UNITED STATES PATENT AND TRADEMARK OFFICE

Office Action Summary

10/736,094

WOOLLENWEBER ET AL.

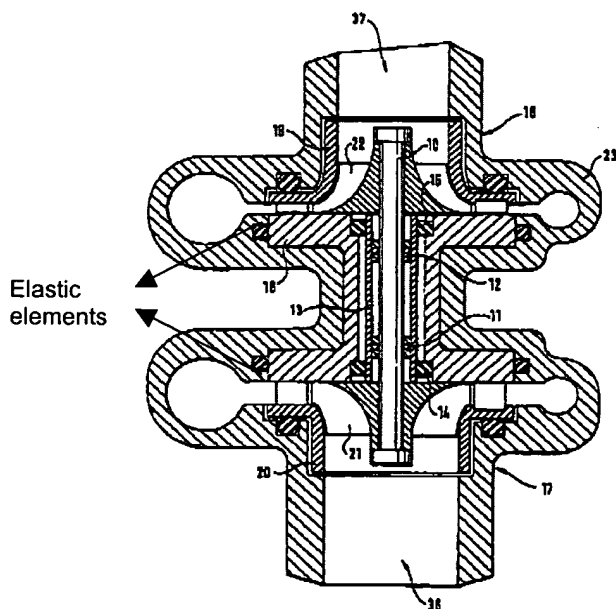
Gutknecht discloses a turbocharger for an internal combustion engine, comprising:

a rotating assembly comprising a turbine wheel (30) and a compressor wheel (22) carried at the opposite ends of a shaft (24) (See Figure); and

a stationary housing (12, 14, 16) comprising an exhaust gas volute (28) for directing engine exhaust gas through said turbine wheel (30) to rotate the rotating assembly, a compressor casing (14) for collection of compressed air from the compressor wheel (22) and a bearing housing (12) (See Figure, and Column 1, lines 44-54); a bearing system for rotatably carrying said rotating assembly within the stationary housing (38, 40), said bearing system comprising an elongated bearing carrier (38), and a pair of ball bearings (40), one ball bearing (40) being axially spaced and carried by the elongated bearing carder adjacent each of its ends, said pair of ball bearings being engaged with said shaft

(24) and rotatably carrying said rotating assembly within said stationary housing
(See Figure, Column 1, lines 65-68, and Column 2, lines 1-9);

wherein the bearing housing (12) contains an annular coolant water passage (via 72, 74, 56, 73, 75) that communicates with the outside surface of the elongated bearing carrier and has an inlet (72, 74) and outlet (73, 75) for admitting and expelling engine coolant (See Figure, Abstract, Column 2, lines 27-68, and Column 3, lines 1-12).

However, Gutknecht fails to disclose an elongated bearing carrier being removably supported by a plurality of elastic elements between the elongated bearing carrier and said bearing housing, wherein said removable elongated bearing carrier has cylindrical outside surface with a peripheral O-ring groove form on each side of said one surface, and said elastomeric bands are O-rings seated in said peripheral grooves; and the bearings being anti-friction ball bearings.
